DC METROPLEX BWI COMMUNITY ROUNDTABLE
c/o Maryland Aviation Administration
P.O. Box 8766
BWI Airport, MD 21240-0766

September 8, 2017

Michael P. Huerta
Administrator
U.S. Department of Transportation
Federal Aviation Administration
800 Independence Avenue, SW
Washington, DC 20591

Figure 1A Runway 28 Departures - shows specific examples of aircraft flying where they were not flying prior to DC Metroplex/NextGen.

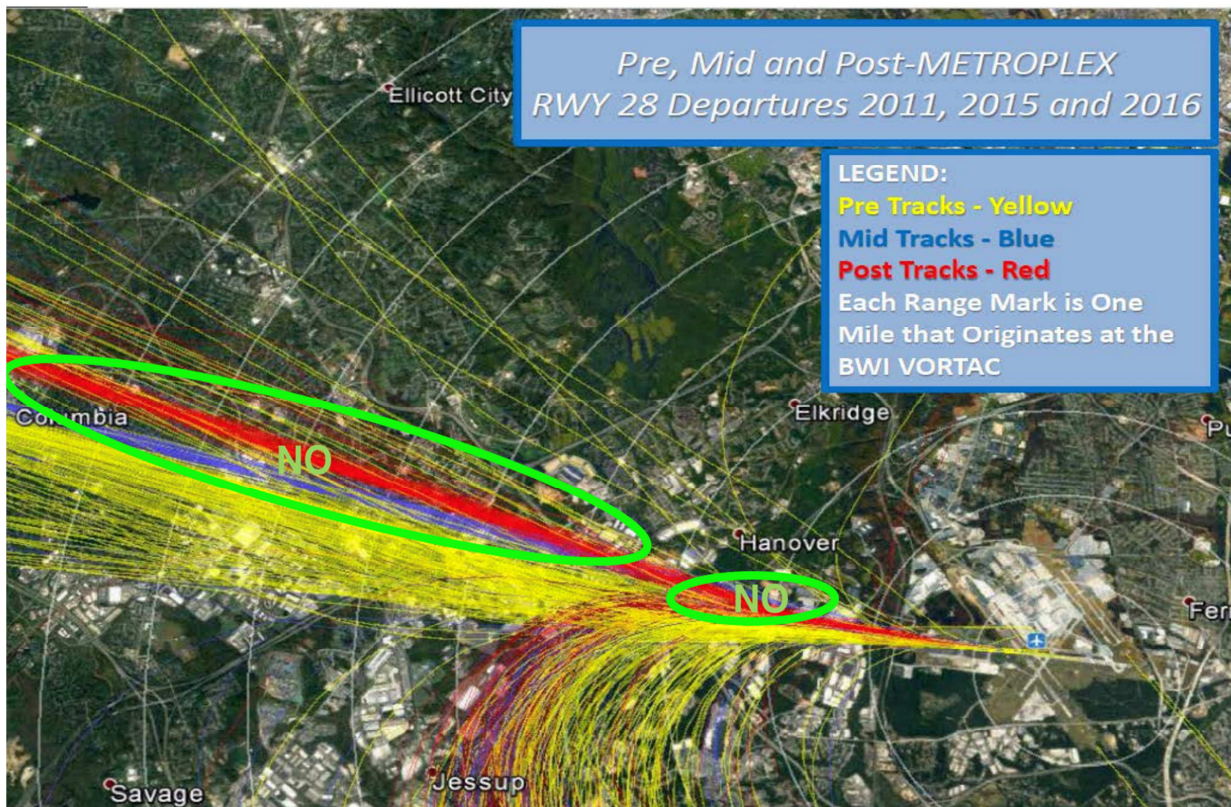
Figure 1B Runway 28 Departures – shows pre-DC Metroplex/NextGen features that need to be restored.

- Runway 28 departure – early turn and path shift to the north and flying south at low altitude
- Runway 15 departure – earlier and lower turn
- Runway 33L and 10 arrivals – flights cleared direct to any waypoints from the RAVNN arrival (including waypoints GRAFE, SPLAT, JANNNS)

We have been advised by Ms. Ray and other FAA representatives that the FAA will be working to revert on the turns and flight paths for runway 28 and 15 departures.

Figure 2A Runway 15 Departures - shows specific examples of planes flying where they were not flying prior to DC Metroplex/NextGen.

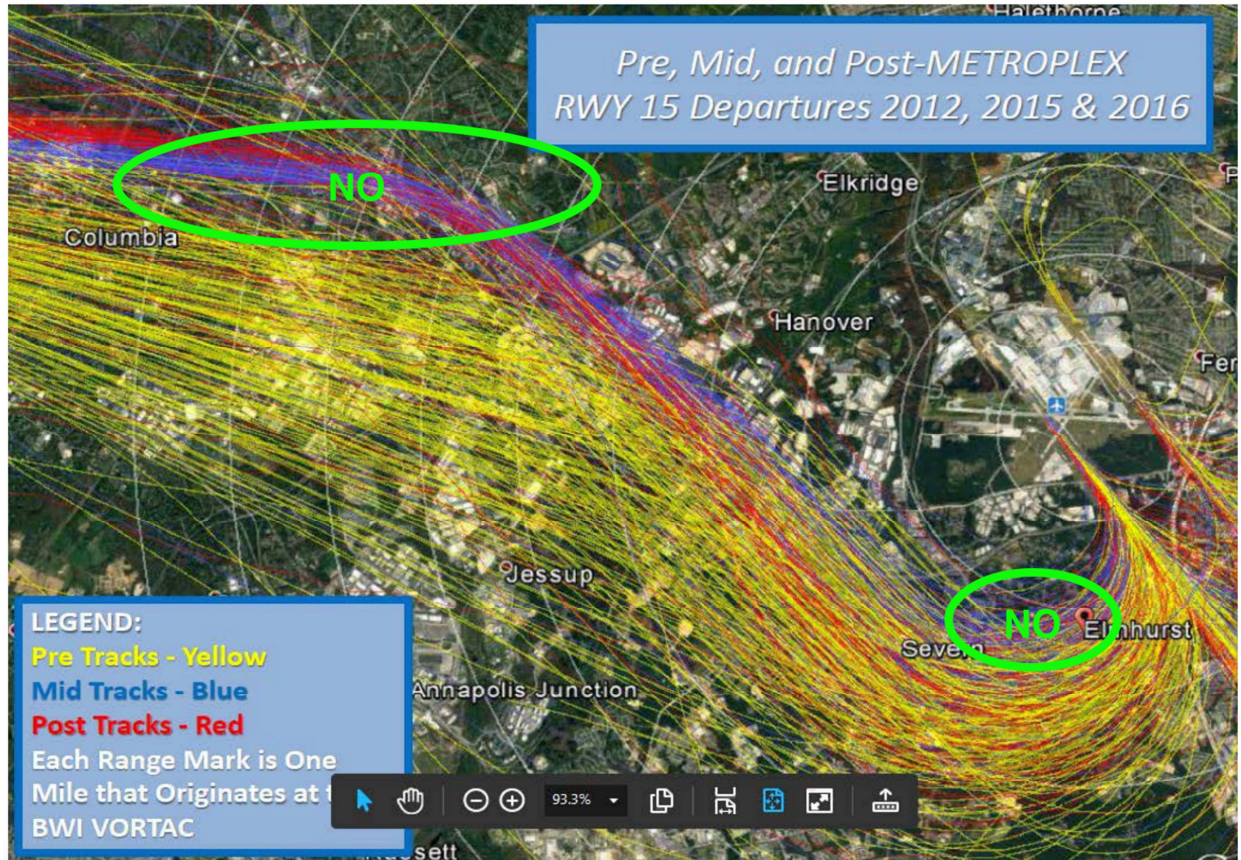
Figure 2B Runway 15 Departures – shows pre-DC Metroplex/NextGen features that need to be restored.

Figure 3A Runway 33L Arrivals - as well as figures 1 and 2 above, show examples of how planes are now concentrated into narrow corridors so that plane after plane are destructive for the residents beneath.

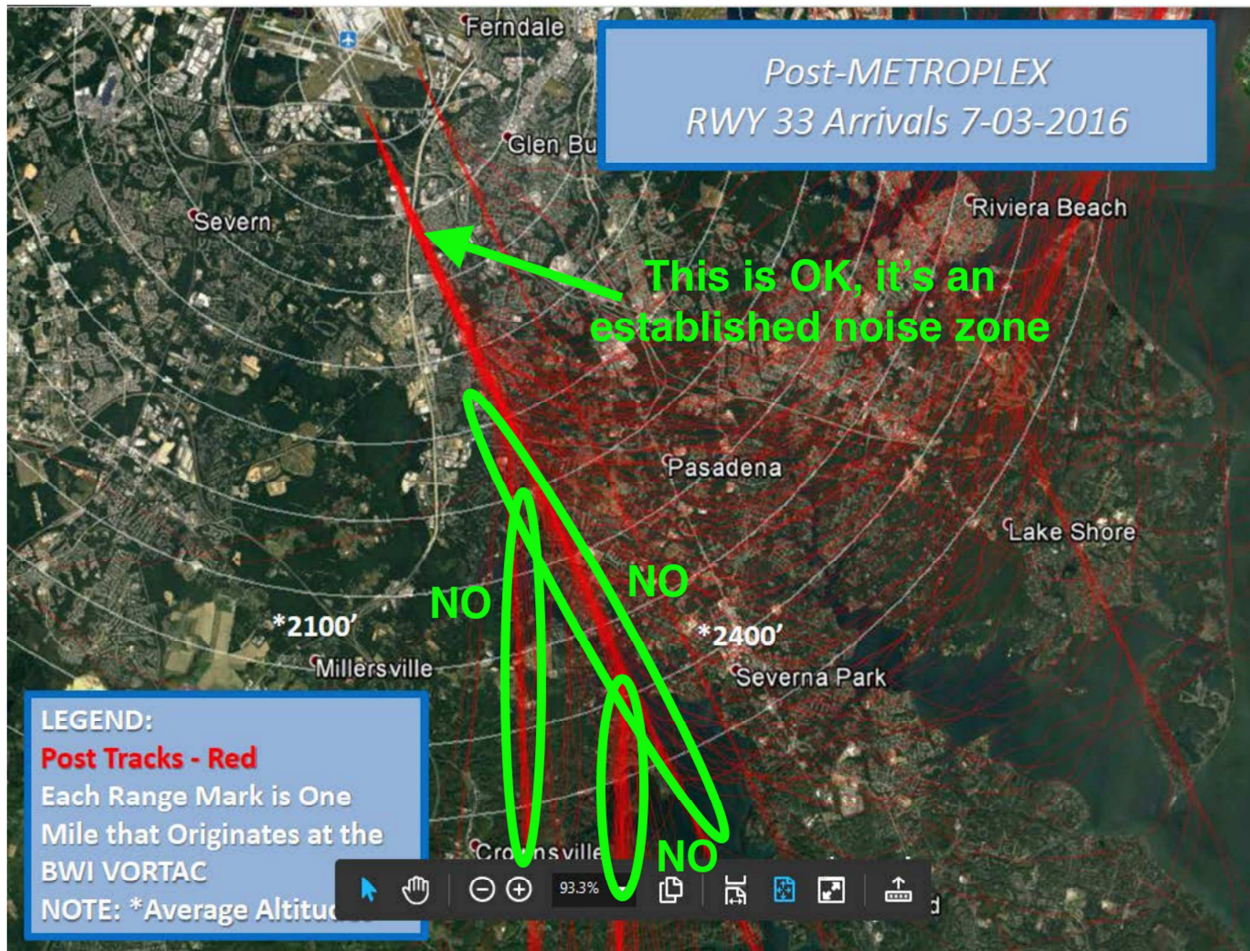
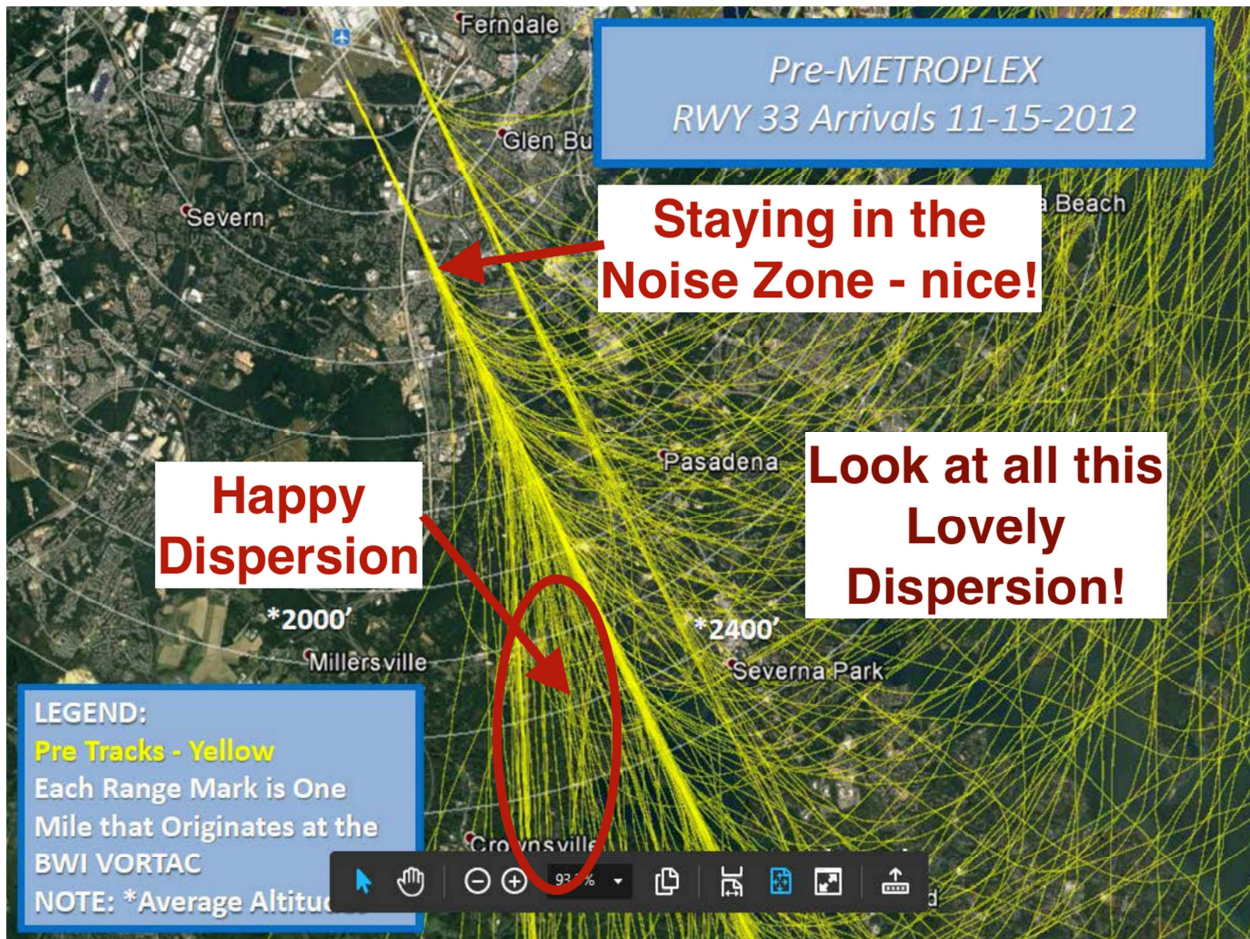
Regarding runway 33L, as discussed at the Roundtable’s July 18, 2017 meeting and requested in the Roundtable’s letter to the FAA, dated July 25, 2017 (see Attachment 7), aircraft would not be “cleared direct” to GRAFE, SPLAT or JANNNS but would be vectored to the final approach course with the objective of achieving dispersion consistent with that illustrated in Attachment 1. Runway 10 arrivals, the ANTHM3 and TRISH2, also have resulted in concentrated flights upstream and at lower altitudes which are unacceptable.

Figure 3B Runway 33L Arrivals - shows dispersion and features of pre-DC Metroplex/NextGen arrivals that must be restored.

Figure 4 Vertical Profiles – shows how planes are flying at lower altitudes than necessary, as has been observed on all arrivals, particularly bothersome with arrivals on Runway 33L and Runway 10.

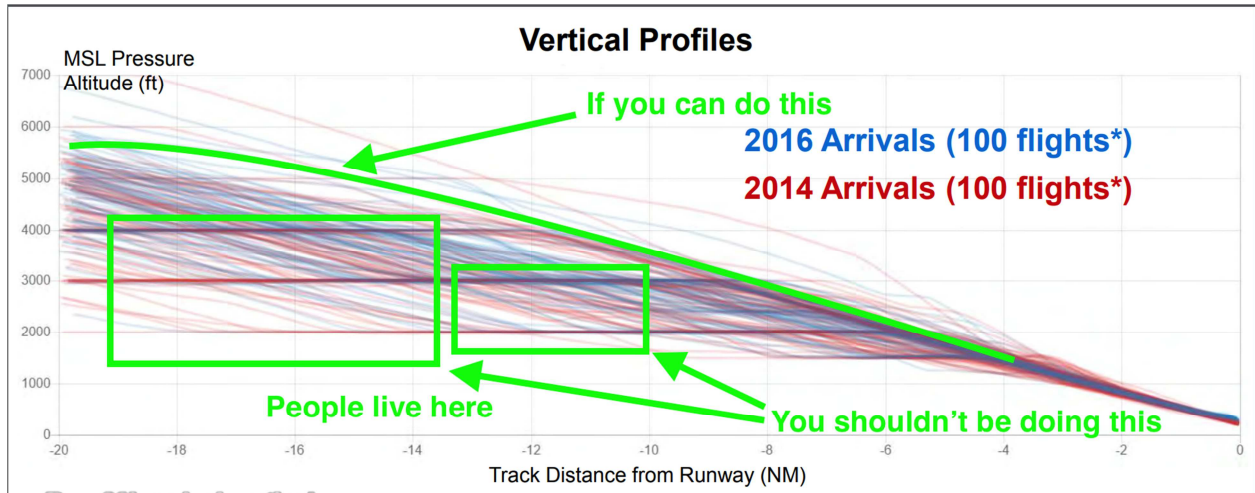
3. FAA procedures permit aircraft to fly at altitudes too low; procedures must be modified to require aircraft to fly at the highest safe altitude at all times during departures and arrivals. Residents universally state that aircraft are flying lower under the DC Metroplex/NextGen scheme than previously. We understand there is conflicting data about how low aircraft are flying and issues regarding whether representations regarding aircraft altitude in DC Metroplex environmental assessment were accurate. As stated by FAA operations representatives for BWI approach control, the frequent ATC procedure of clearing aircraft for visual approaches has had the effect of alleviating an aircraft's obligation to comply with published arrival and approach procedure altitudes resulting in much lower flying aircraft. This has directly translated into an unacceptably lower altitude for regular flight operations. For arrival aircraft this has affected flights from as far out as the RAVNN waypoint on the RAVNN arrival and their joining of the final approach corridor into 33L at lower than IFR standard glideslope intercept altitudes. For 15R departures this has resulted in aircraft turning at lower altitudes; altitudes should be restored to previously established altitudes and the turn should be restored to 1 DME.

Also in our July 25 letter to the FAA, we have requested that the FAA implement the cooperation and training as proposed by Robert Owens at the July 18 meeting as soon as possible. We further request that FAA and airport procedures and rules be changed so that achieving and maintaining the highest safe altitude for departing and arriving aircraft is a requirement, rather than only a voluntary undertaking. All flights given visual clearances must not descend below published altitudes for the entire arrival and approach procedure.
